ADDENDUM TO VISUAL IMPACT ASSESSMENT (VIA)

CBM Caledon Project

CA-GLD-19129150

30 October 2025

Drawing No. **FIGURE 18**

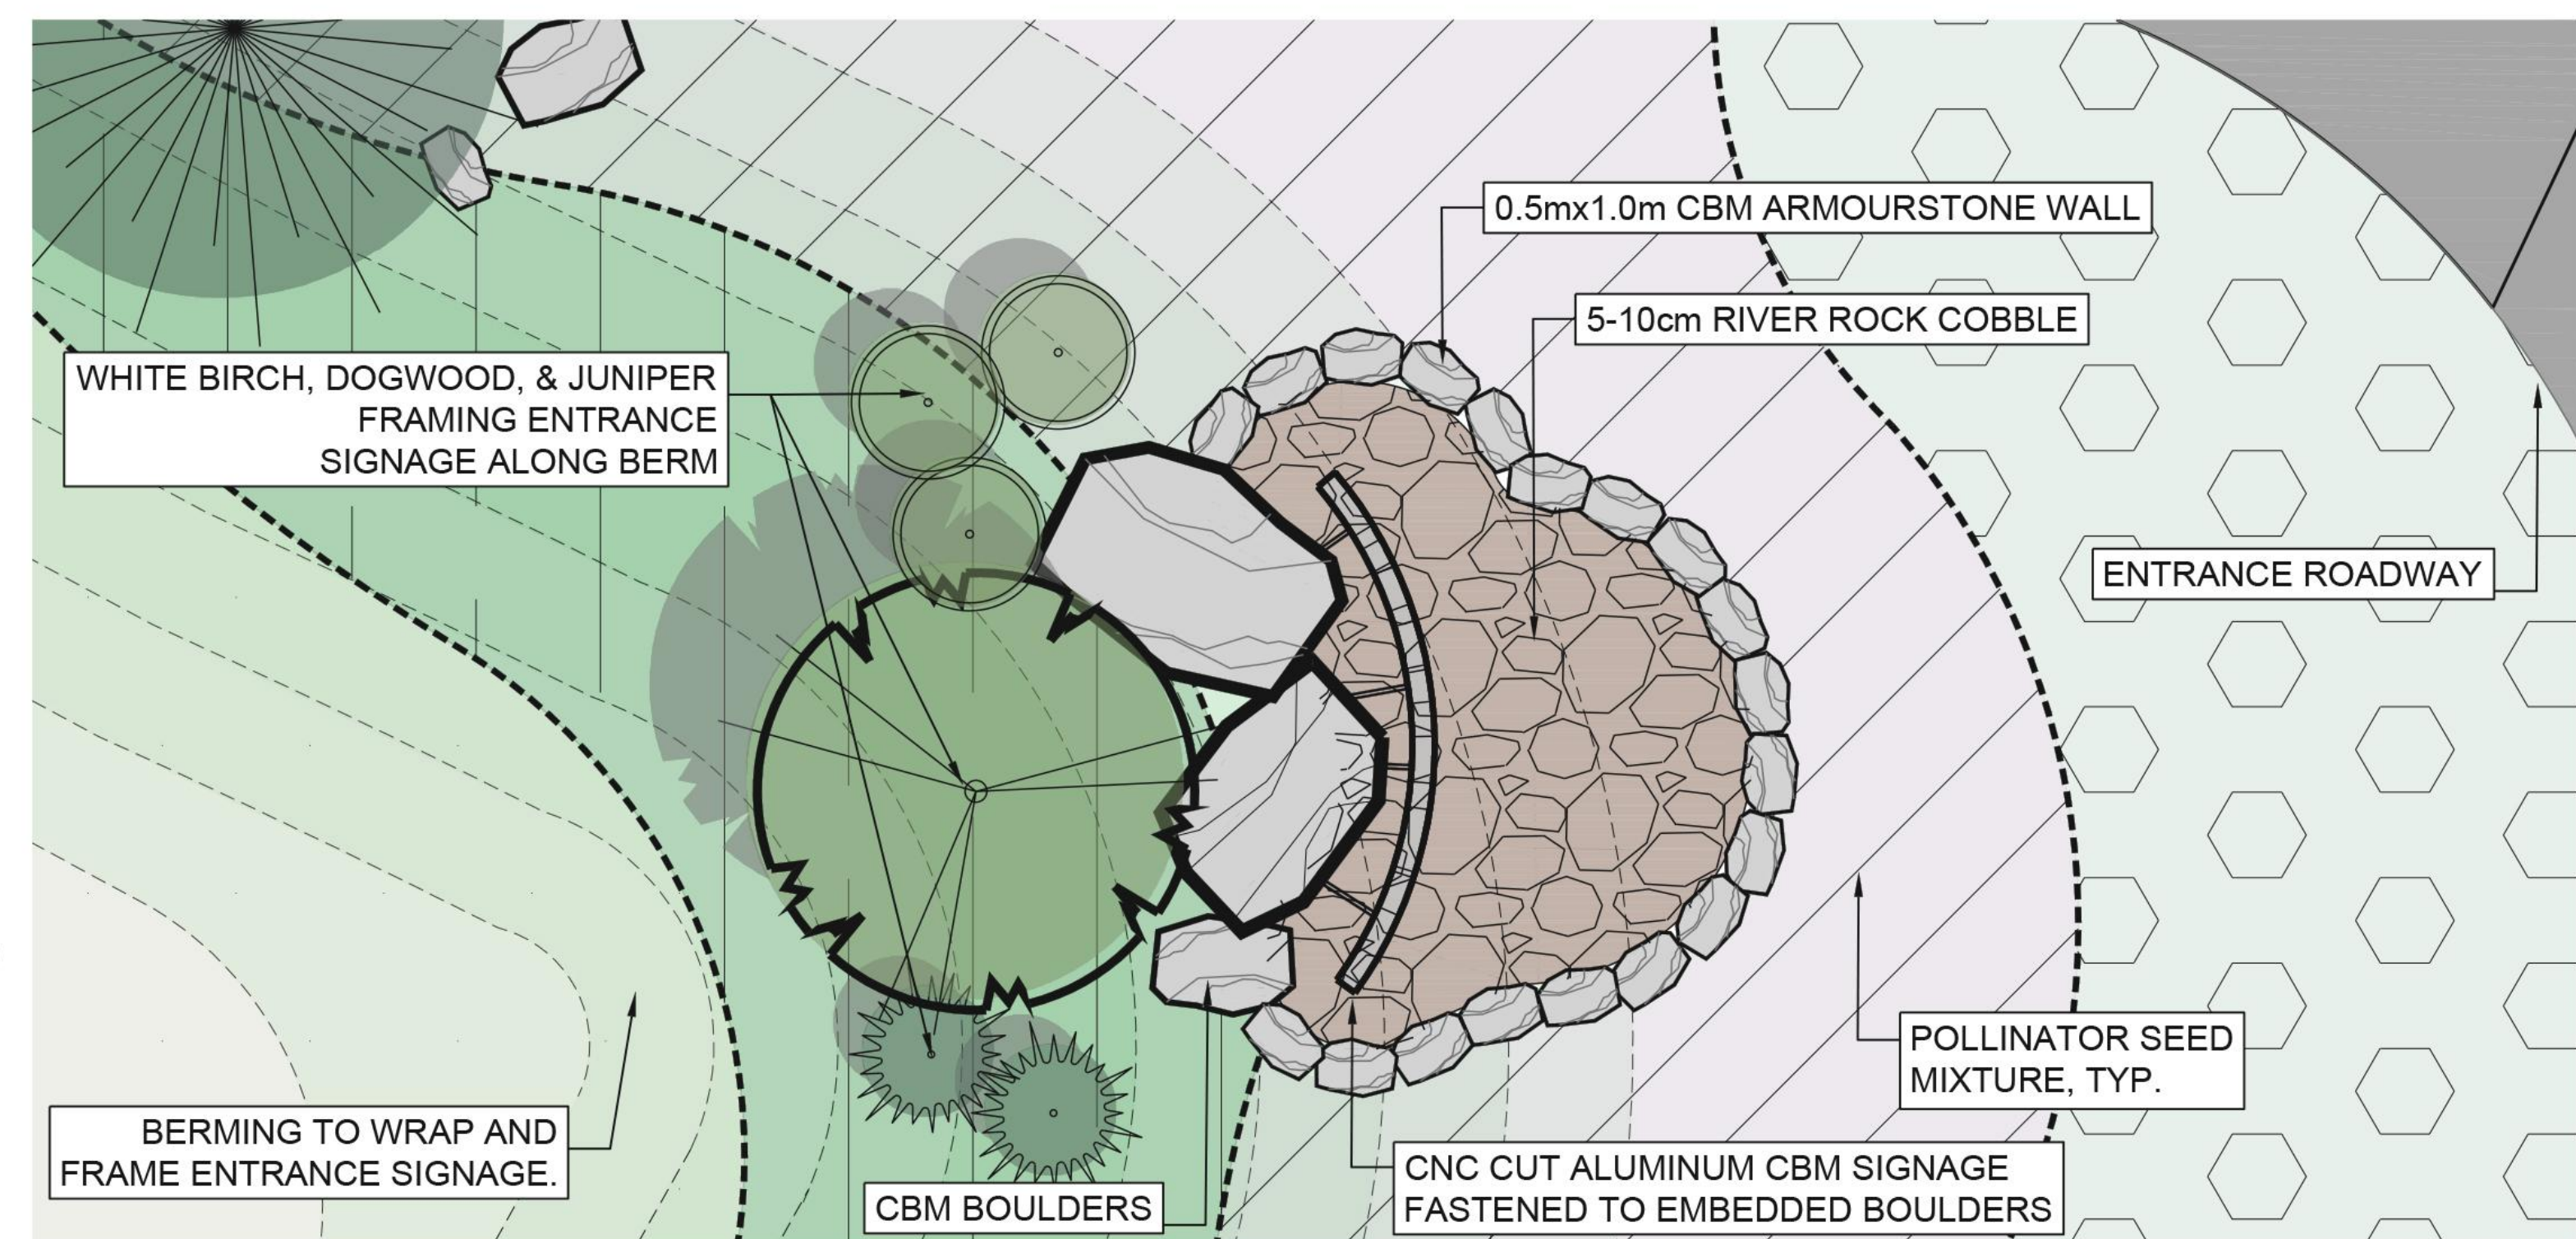
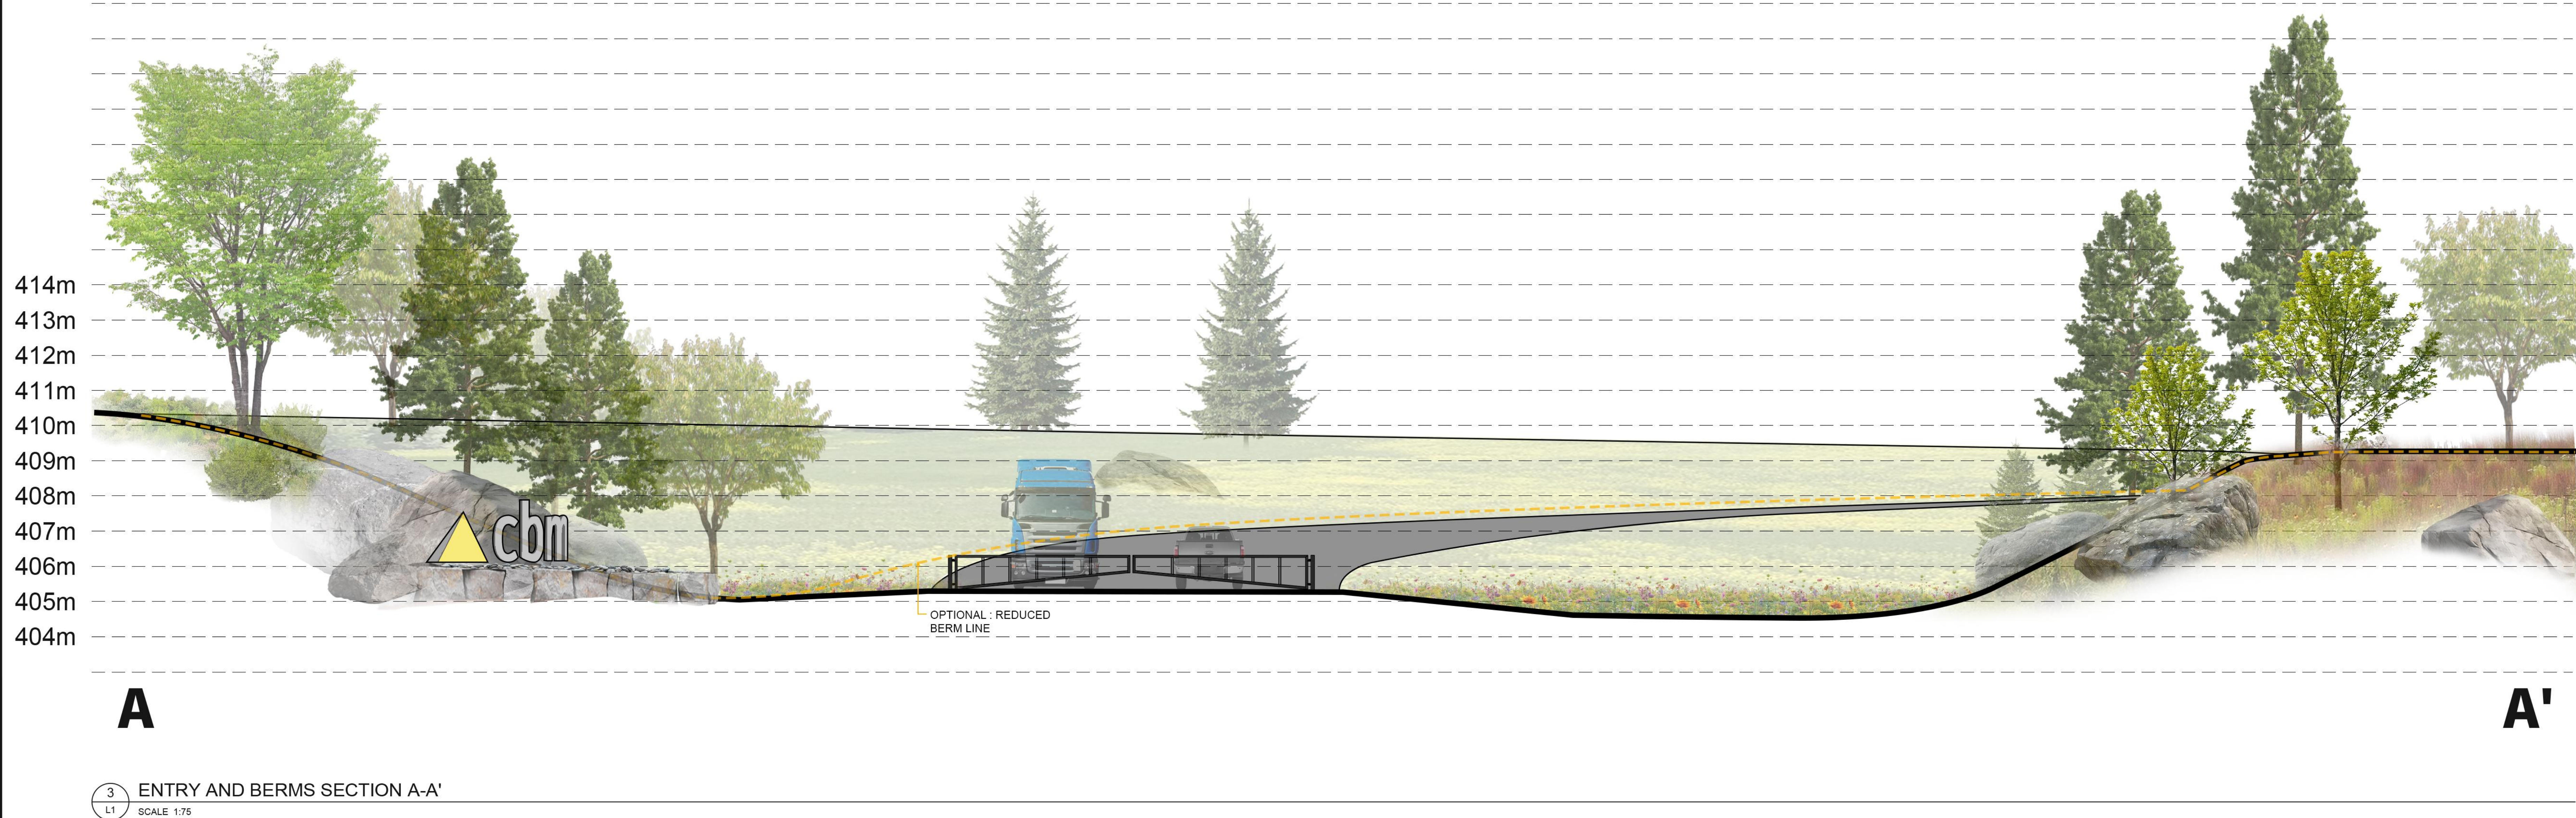
Based on the VIA Addendum, and the updated conceptual front entrance design, the visual Site Plan Technical Recommendations found on Drawing 3 of 4 of the July 2025 MHBC ARA Site Plans shall be updated to include the following Technical Recommendations. These recommendations pertain to the conceptual front entrance design only which is shown on Figure 18 in the VIA Addendum.

- 1) The site entrance shall be planted with the following grasses in the areas identified on Figure 18 in the VIA Addendum:

- 2) The site entrance shall be planted with the number and size of tree and shrub species in the areas identified on Figure 18 in the VIA Addendum.

- 3) The site entrance simulation found on Drawing 3 of 4 of the July 2025 MHBC ARA Site Plans shall be replaced with Figure 18 of the VIA Addendum.
